T ECHNICAL INFORMATION

63646
(Page 1 of 2)

Subject ▶ Change of Housing, Set Plate, etc.

For Models ▶ 6095D

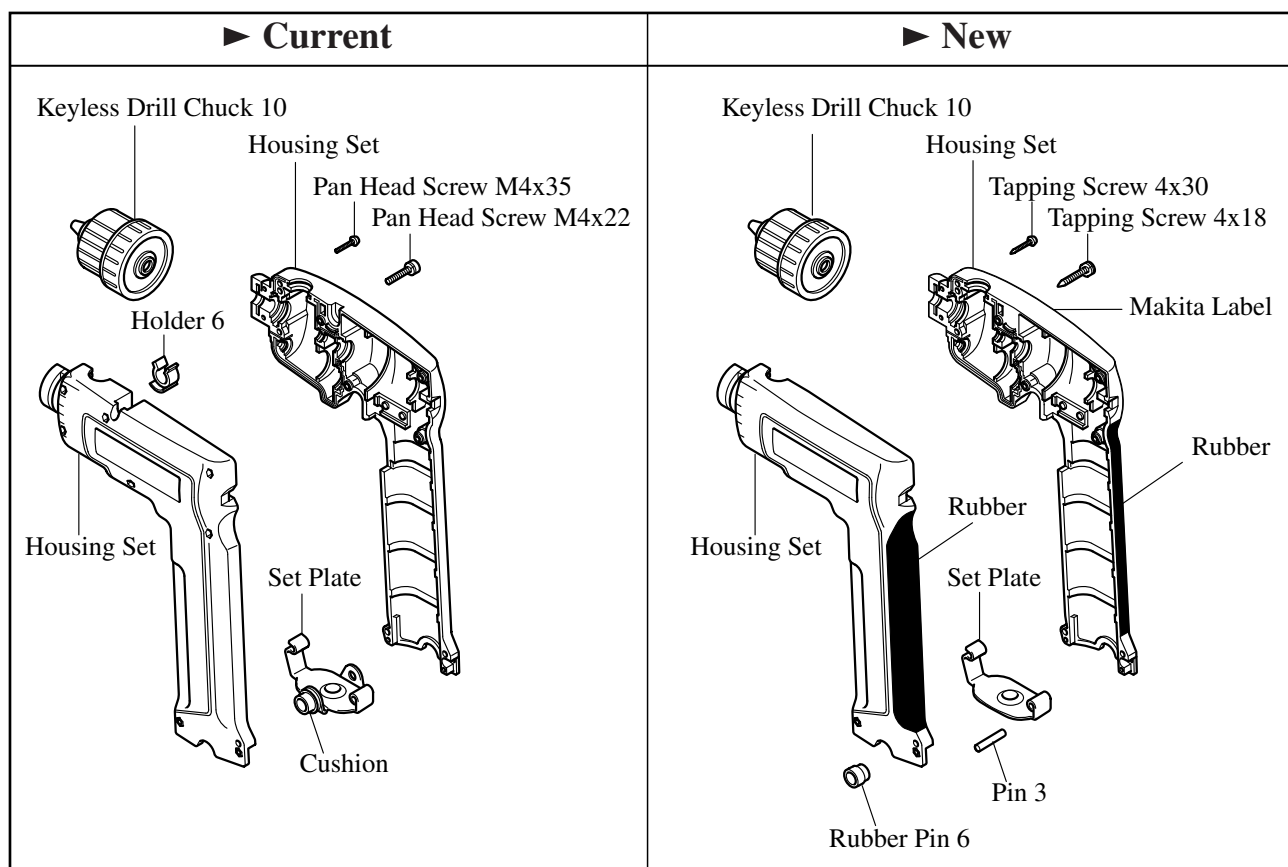
1. Housing without rubber has been replaced by one with rubber.
2. Set Plate with cushion has been replaced by one without cushion.
3. Pin 3 has been added.
4. Rubber Pin 6 has been added.
5. Makita Label has been added.
6. Pan Head Screws M4x22 (Item No. 001) have been replaced by Tapping Screws 4x18.
Pan Head Screws M4x35 (Item No. 002) have been replaced by Tapping Screws 4x30.
7. Holder 6 has been eliminated.
8. Keyless Drill Chuck 10 has been changed.

Item No.	Current part		Q'ty	I/C	New part		Q'ty	Note
003 044	Housing Set 182803-5		1	No	Housing Set 183196-3		1	<div style="text-align: center;"> ↑ Interchangeable as a set ↓ </div>
049					Pin 3 256158-5		1	
050					Rubber Pin 6 263022-3		2	
051					Makita Label 819063-3		1	
001	Pan Head Screw M4x22 911143-2		6	No	Tapping Screw 4x18 265995-6		6	
002	Pan Head Screw M4x35 911163-6		2	No	Tapping Screw 4x30 266050-7		2	
043	Holder 6 411640-3		1				—	
047	Set Plate 163157-9		1	No	Set Plate 344549-3		1	
008	Keyless Drill Chuck 10 192016-0		1	Yes	Keyless Drill Chuck 10 763154-1		1
